November 28, 2022

Subject: Foster City Elementary School HVAC Replacement
San Mateo - Foster City School District
Aedis Project No. 2021011.05
DSA Application #01-120182

ADDENDUM NO. 1

PARTIAL DEMOLITION FLOOR PLAN - LIBRARY BUILDING

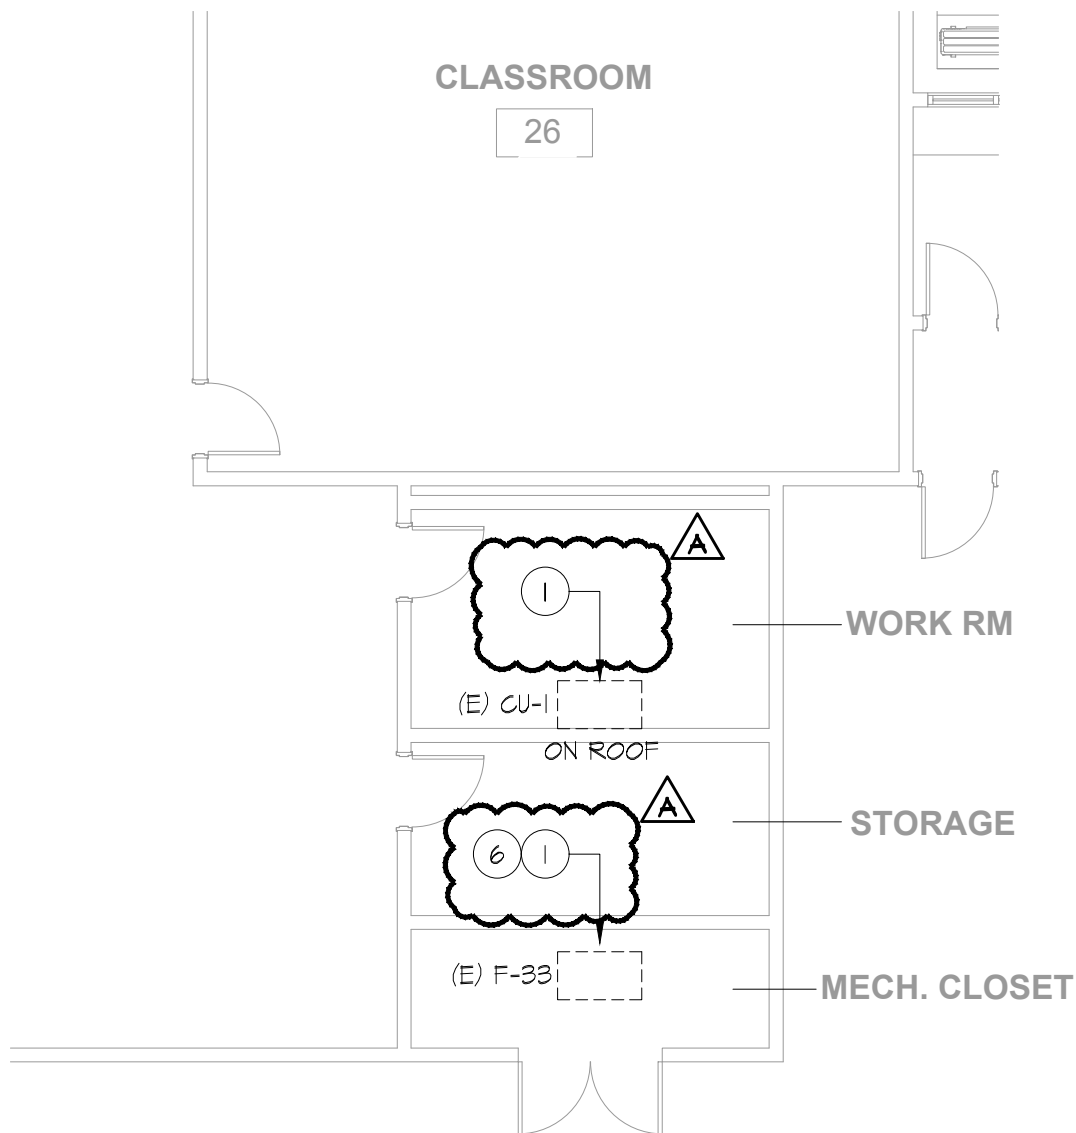
ITEM NO. 1.5: DRAWING SHEET E2.3 – DEMOLITION FLOOR PLANS – BLDG K, L, ANNEX & LIBRARY

Revise: Background to make demo notes clear per AD1-E2.3.

SHEET # AD1-
E3.1

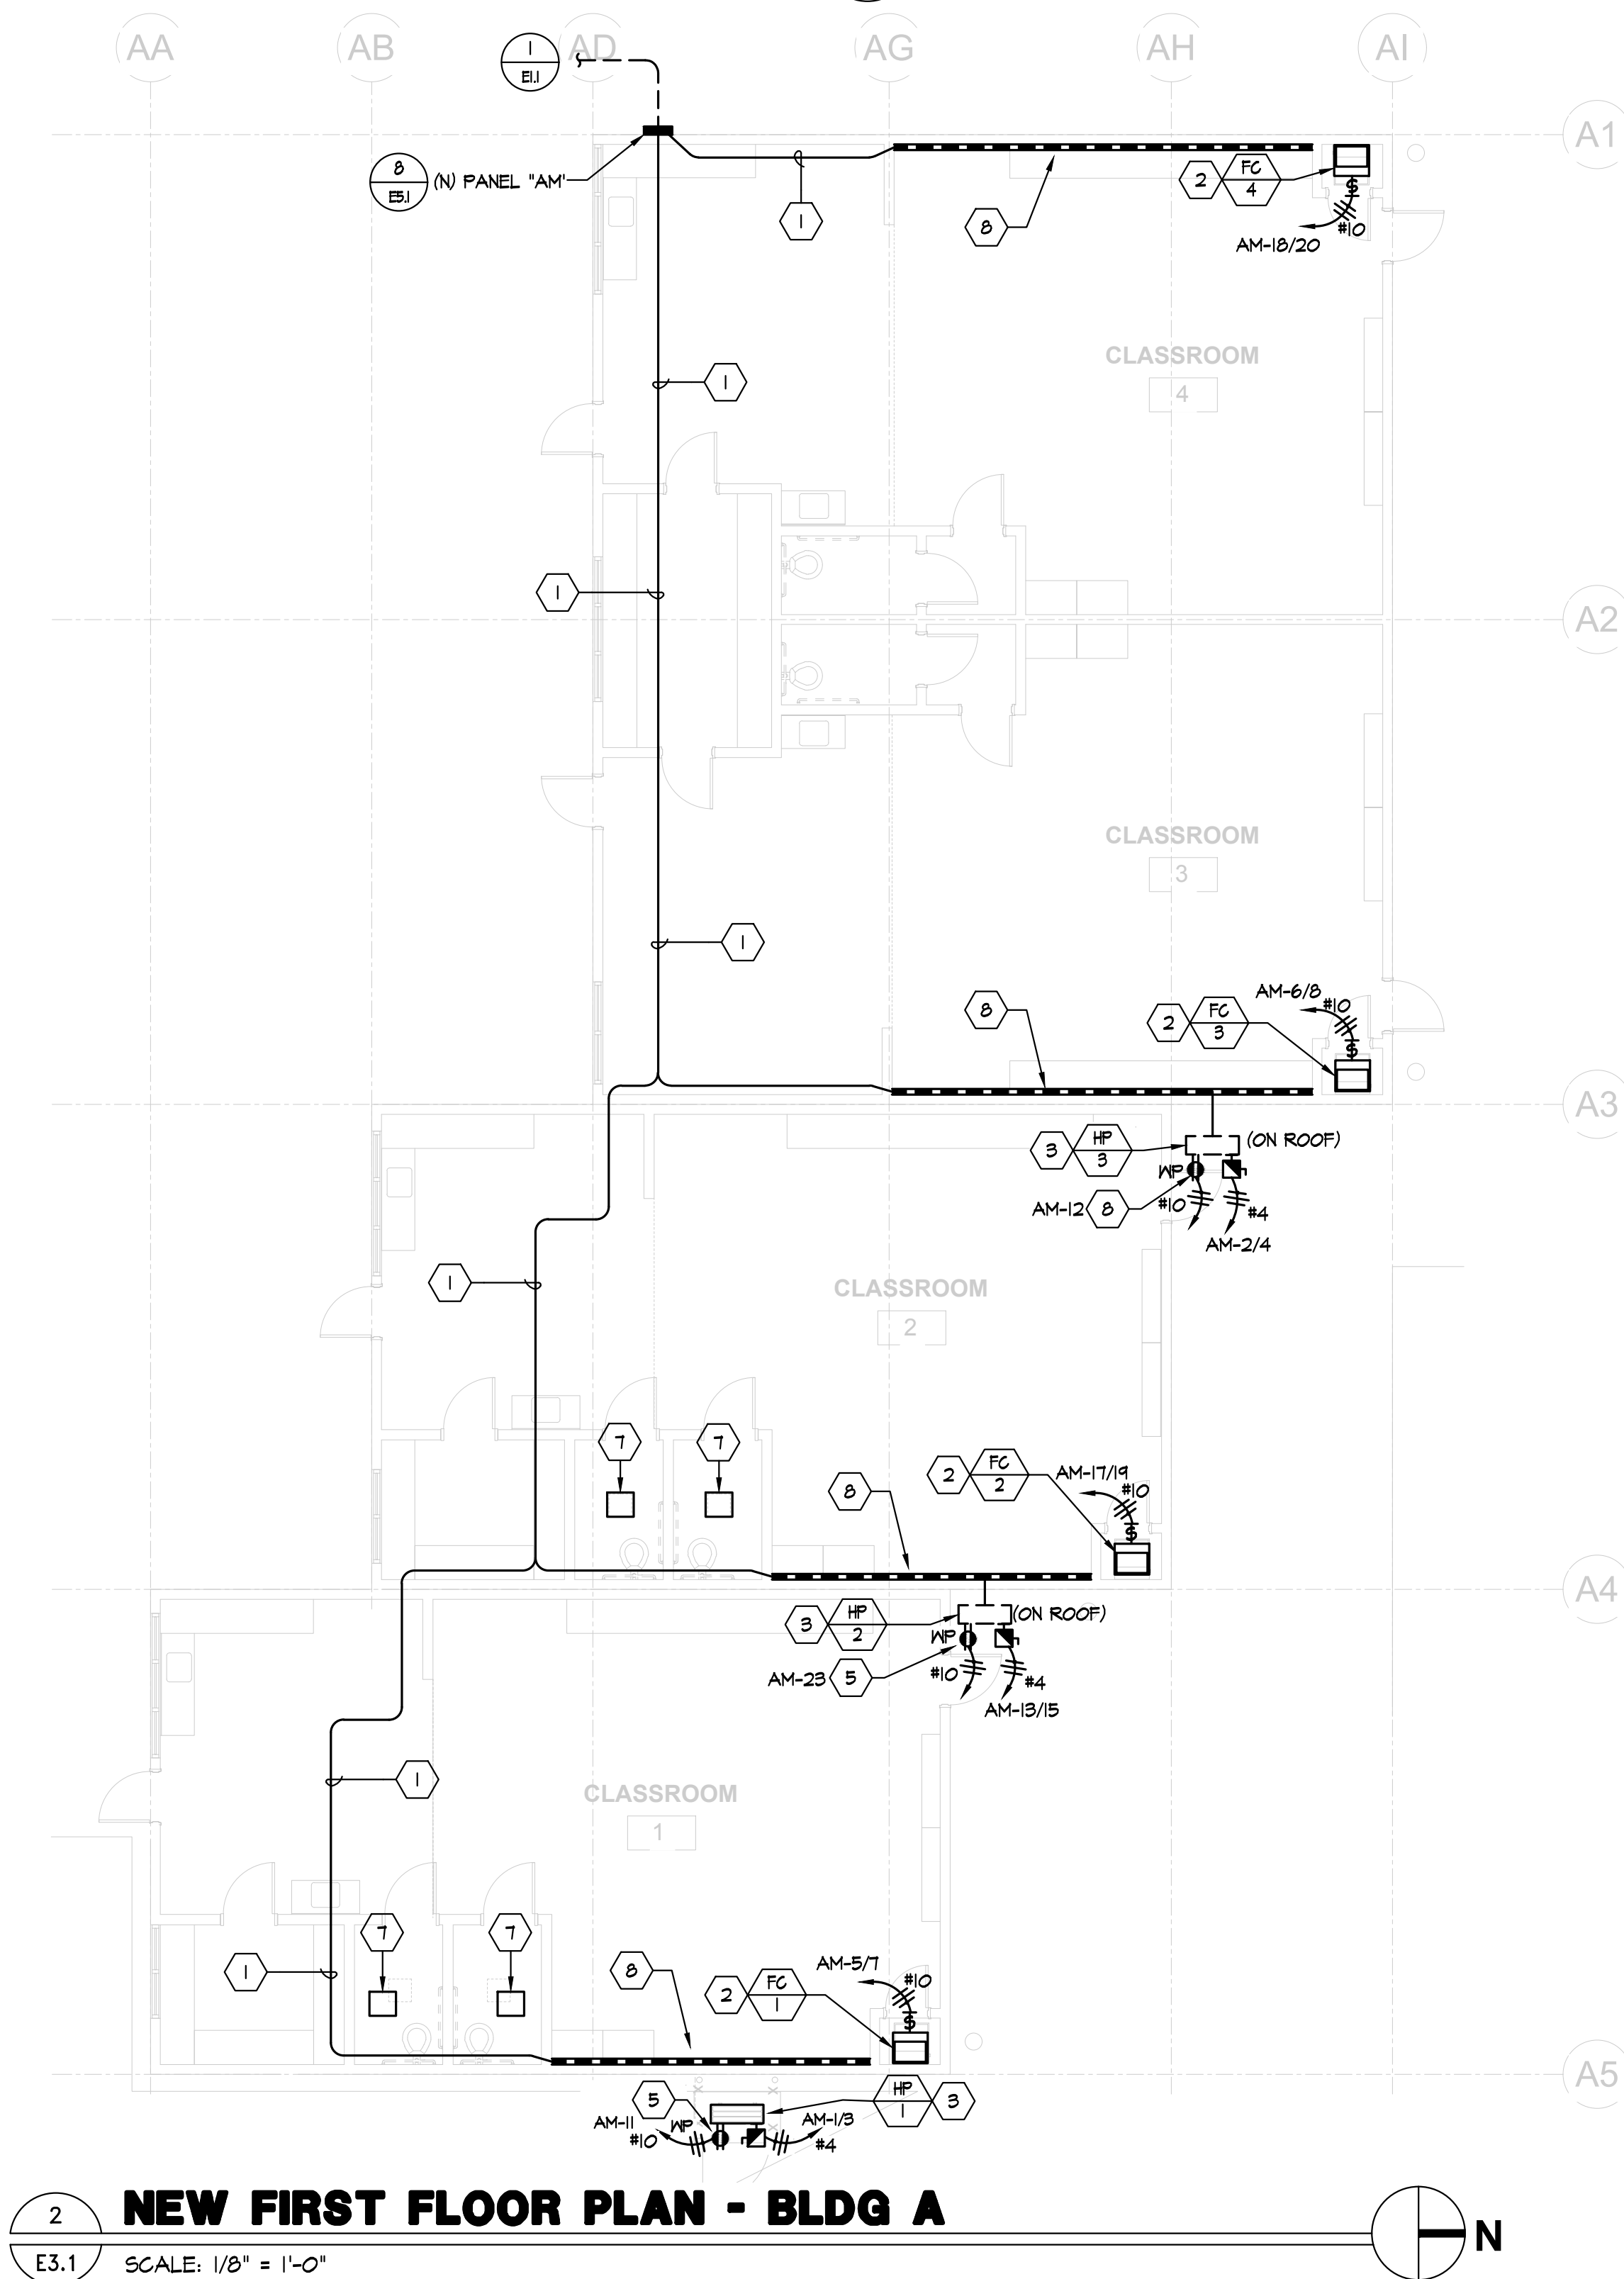
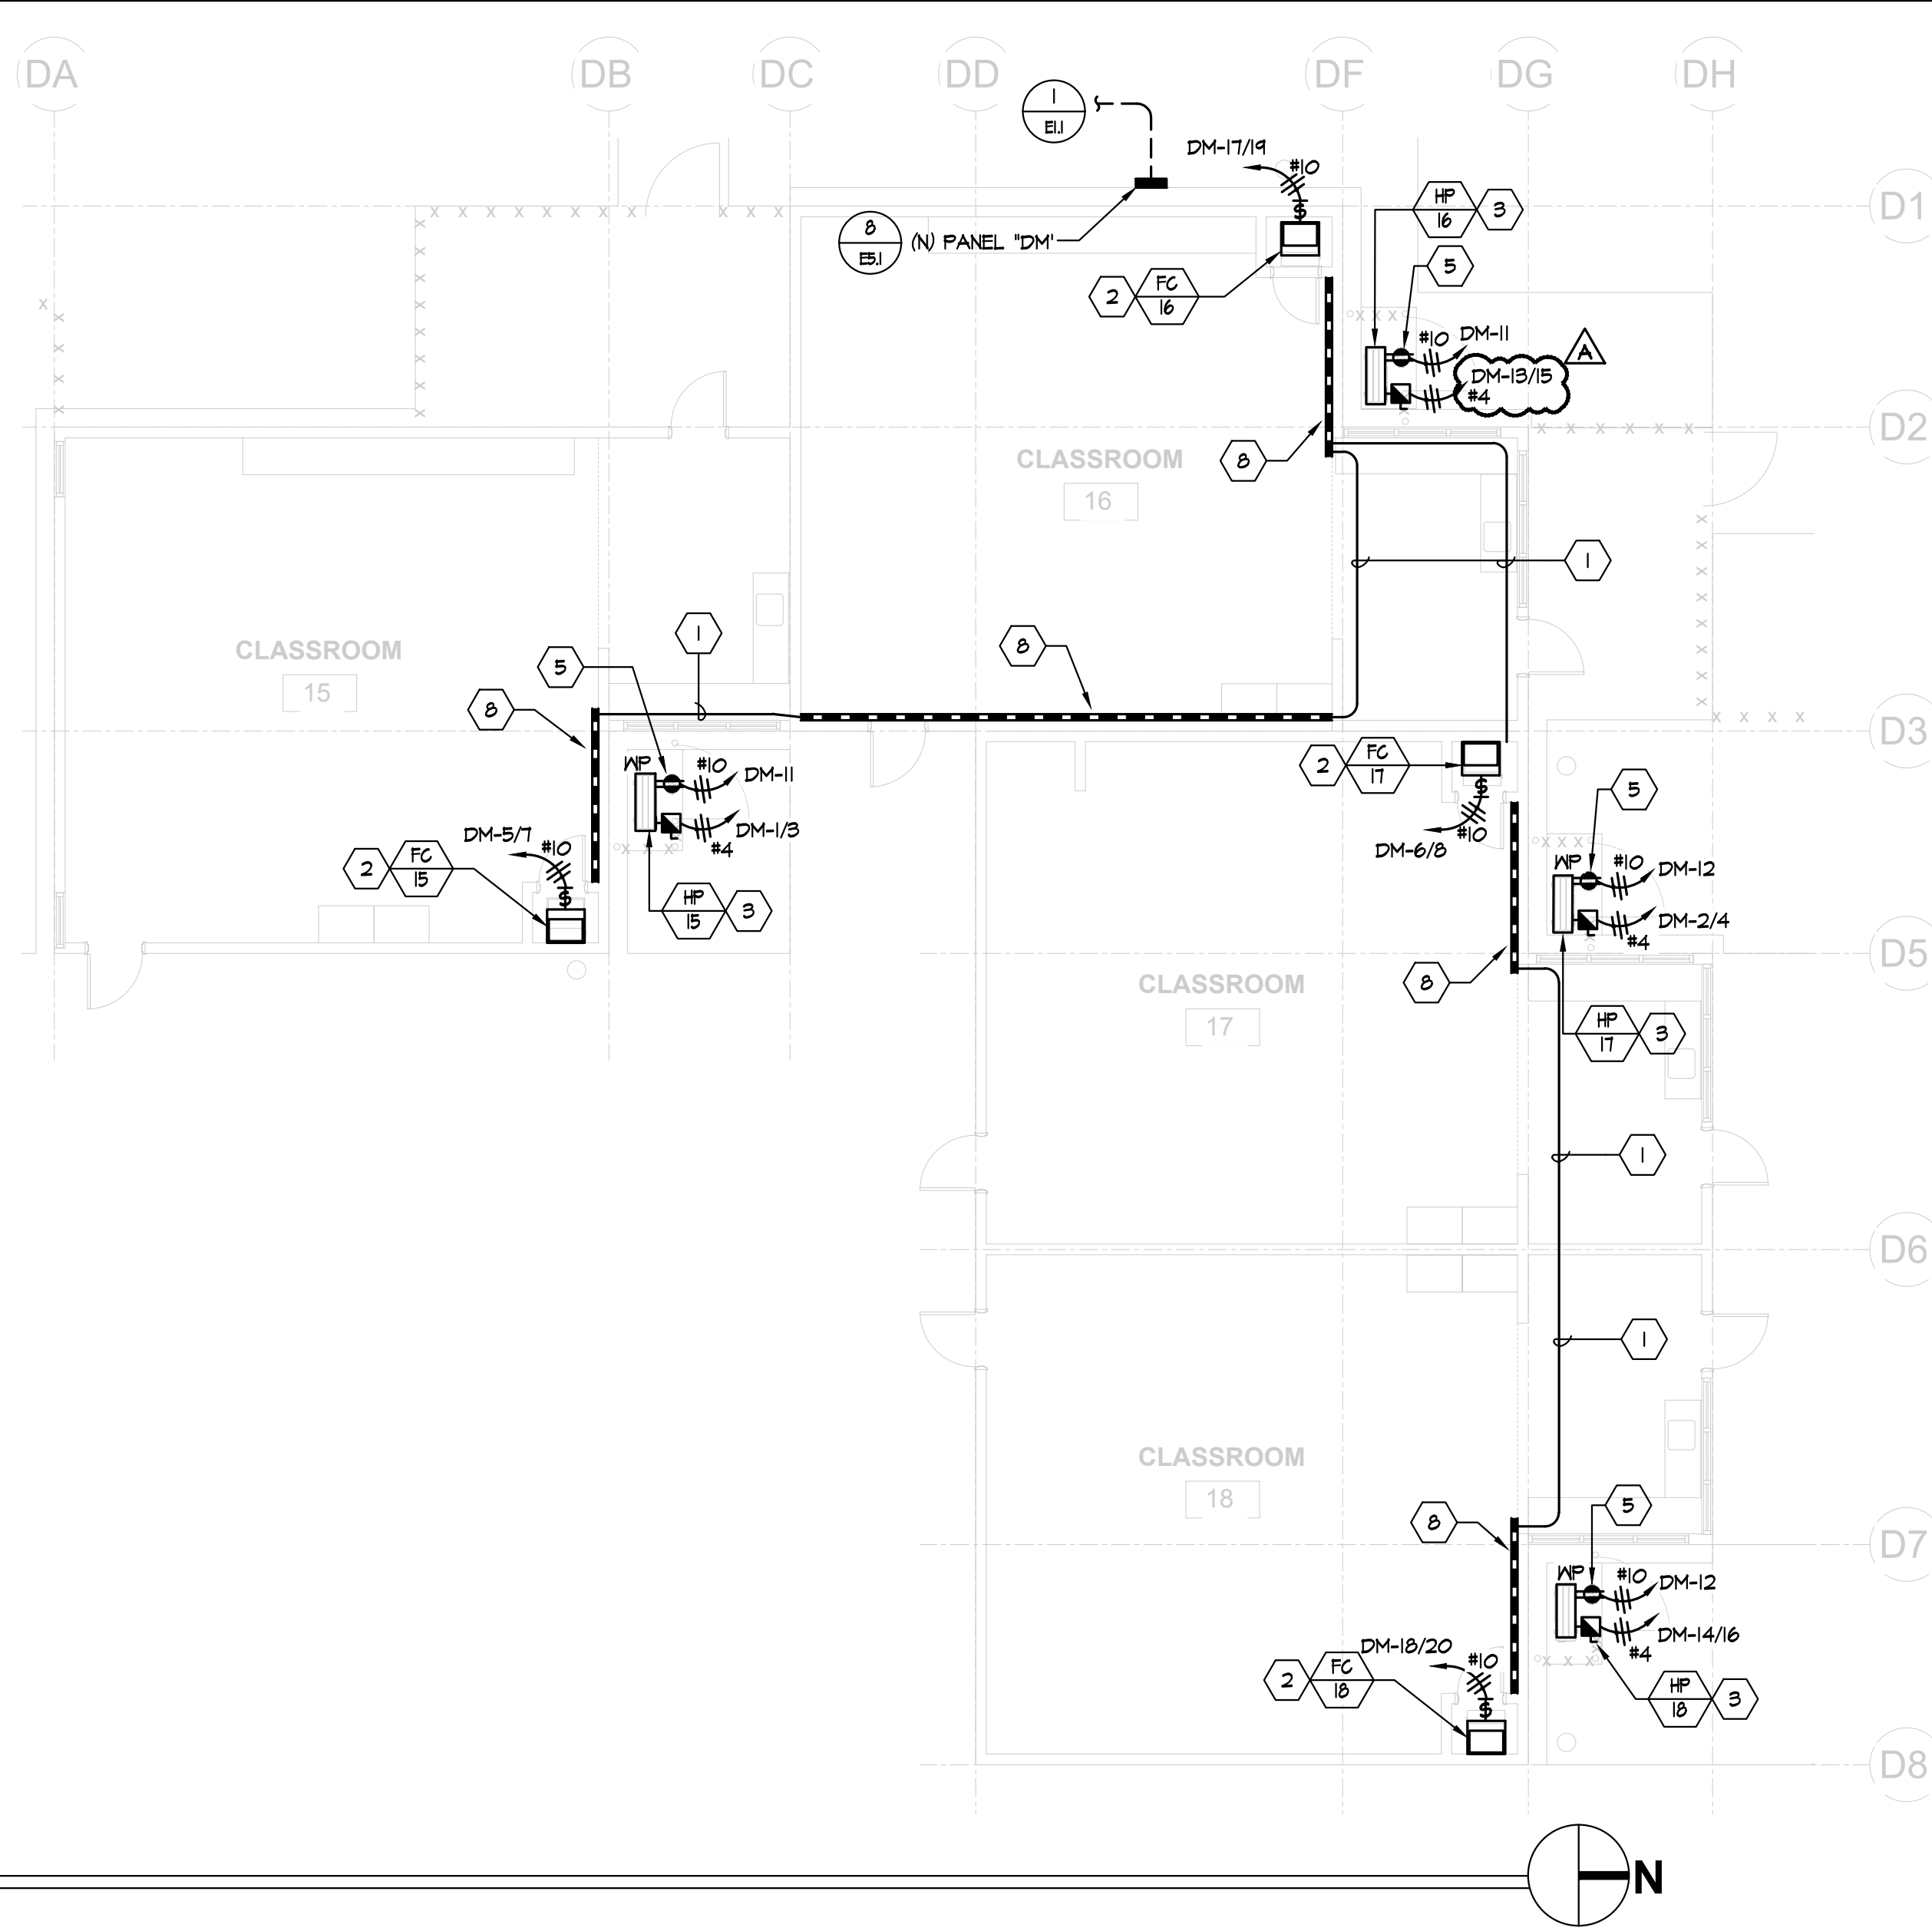
ITEM NO. 1.6: DRAWING SHEET E3.1 – NEW FLOOR PLANS – BLDG A, B, C & D

Revise: Sheet Note #4 per AD1-E3.1.

Revise: Unreadable text to make text legible per AD1-E3.1.
